SERVICE BULLETIN

M-1022

NEW HEADLAMP ASSEMBLY AND WIRING HARNESS CONNECTOR

Figure 1. Identification of NAL Headlamp Assembly

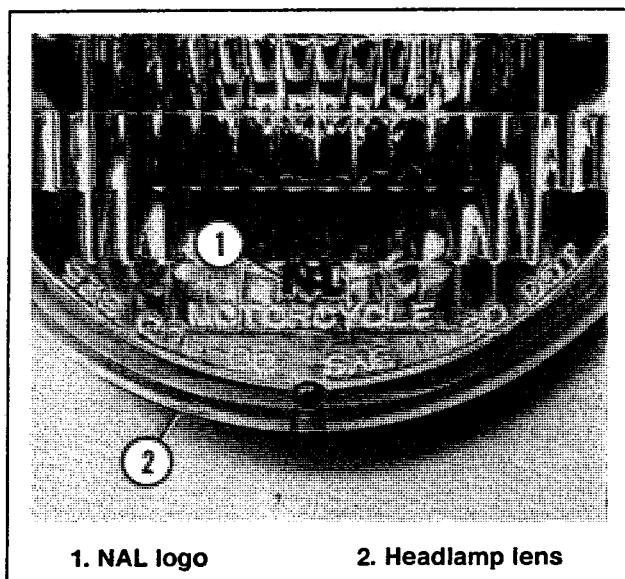
This Service Bulletin is being issued to inform dealers about a new halogen headlamp assembly (H-D Part No. 67698-81C), which was introduced into production in January 1992 as a running change on the following 1992 models:

See Figure 1. You may identify the new headlamp assembly by the "NAL" logo (1) molded into the bottom of the headlamp lens (2).

Figure 2. NAL Headlamp Element (Bulb)

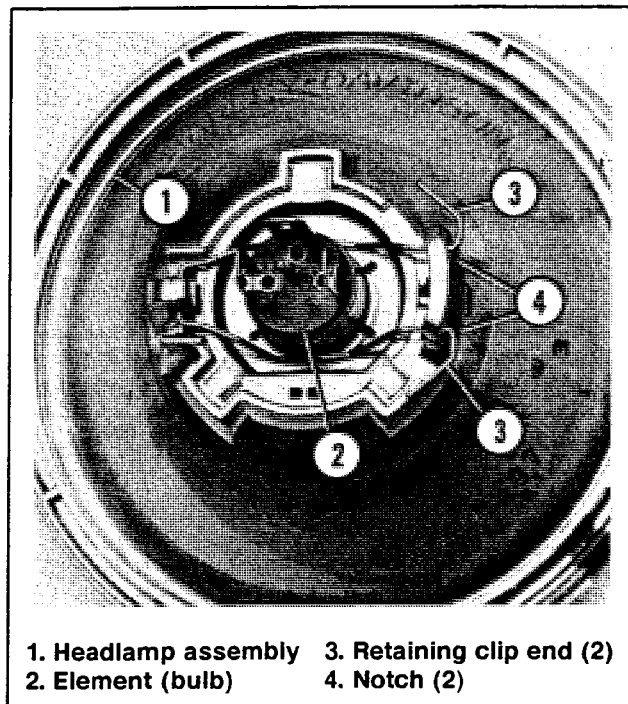
See Figure 2. The new NAL headlamp assembly (1) uses the same replaceable H-4 halogen element (bulb) (2) that was used on the previous headlamp assembly (H-D Part No. 67698-81B, made in France by Auteroche). However, due to the different design of the NAL headlamp lens, a revised headlamp alignment procedure is required in order to conform with all applicable federal and state standards of conspicuity and luminosity. See NAL HEADLAMP ALIGNMENT in this Service Bulletin.

Figure 3. NAL Headlamp with Locking Wiring Harness Connector

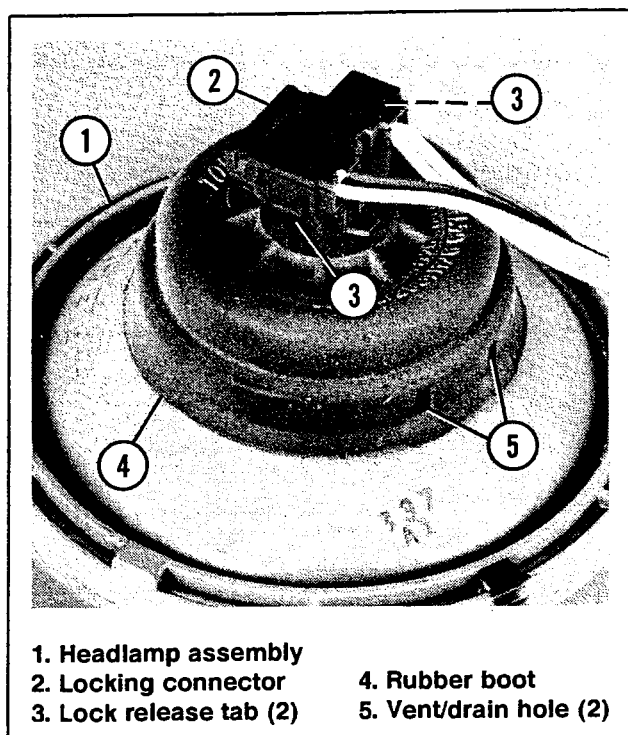
See Figure 3. In addition to the new headlamp assembly (1), a new headlamp wiring harness connector (2), with locking terminals, was introduced into production in January 1992 as a running change on the following 1992 models:

You may identify the new locking connector (2) by lock release tabs (3) on the connector's right and left sides. When disconnecting the connector from the headlamp terminals, firmly depress both lock release tabs; this will release the locking mechanism of the connector's right and left terminals from the headlamp's right and left terminals (note that the center terminal does not have the locking feature). While holding down both lock release tabs, carefully pull connector from headlamp terminals. See NAL HEADLAMP ELEMENT REMOVAL/ INSTALLATION in this Service Bulletin.

1. Remove headlamp assembly from its housing, as described in appropriate Service Manual.
2. For NAL headlamp models **with** locking wiring harness connector (2) (i.e. - all XLH Sportster, and all FXR except FXLR and FXRT), see Figure 3. Firmly depress lock release tabs (3) on left and right sides of connector. While holding both lock release tabs down, carefully pull connector from headlamp terminals.
- For NAL headlamp models **without** locking wiring harness connector (i.e. - FXLR, FXRT, FXSTC, FXSTS, and all FXD Dyna Glide), carefully pull connector from headlamp terminals.
3. See Figure 3. Remove rubber boot (4) from back of headlamp assembly (1).
4. See Figure 2. Depress wire retaining clip ends (3) to unhook them from notches (4) in headlamp assembly (1).

5. Pivot wire retaining clip away from element (2). Remove element from headlamp assembly.
6. Installation is the reverse order of removal. See Figure 3. Rubber boot (4) must be installed with vent/drain holes (5) positioned to the bottom.
7. Check headlamp alignment according to NAL HEADLAMP ALIGNMENT procedure in this Service Bulletin.

Figure 4. Revised NAL Headlamp Alignment

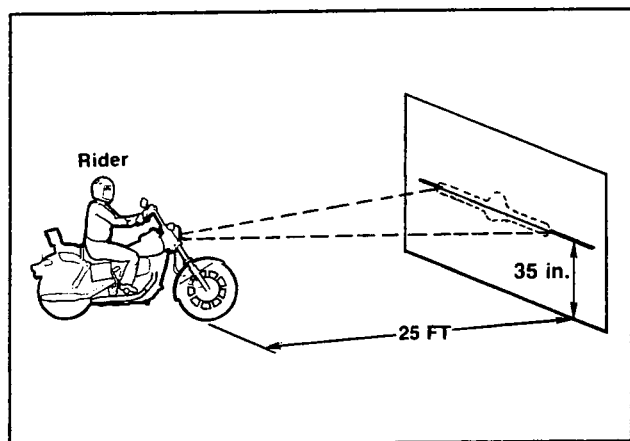
Whenever required, perform the following headlamp alignment procedure **only** on those motorcycles equipped with the new NAL headlamp. Continue to use the original Service Manual alignment procedure on motorcycles equipped with any other headlamp.

1. Verify correct front and rear tire inflation pressure.
2. See Figure 4. Place motorcycle on level floor (or pavement) in an area with minimum light.

3. Point front of motorcycle toward a screen or wall which is 25 feet away from front tire contact patch on floor (i.e. -- directly below front axle).
4. Draw a horizontal line, on screen or wall, which is 35 inches above floor.

5. Have a person, whose weight is roughly the same as that of the principal rider, sit on motorcycle seat. Weight of rider will compress vehicle suspension slightly.
6. Stand motorcycle upright with both tires resting on floor and with front wheel held in straight alignment (directly forward).
7. Turn ignition/light switch to "LIGHTS" or "IGNITION" position. Set handlebar switch to high-beam position.
8. Check light beam for proper height alignment. Main beam of light (broad, flat pattern of light) should be centered on horizontal line of screen or wall (i.e. - equal area of light above and below line).
9. Check light beam for proper lateral alignment. Main beam of light should be directed straight ahead (i.e. - equal area of light to right and left of center).
10. Make adjustments to headlamp alignment as required.
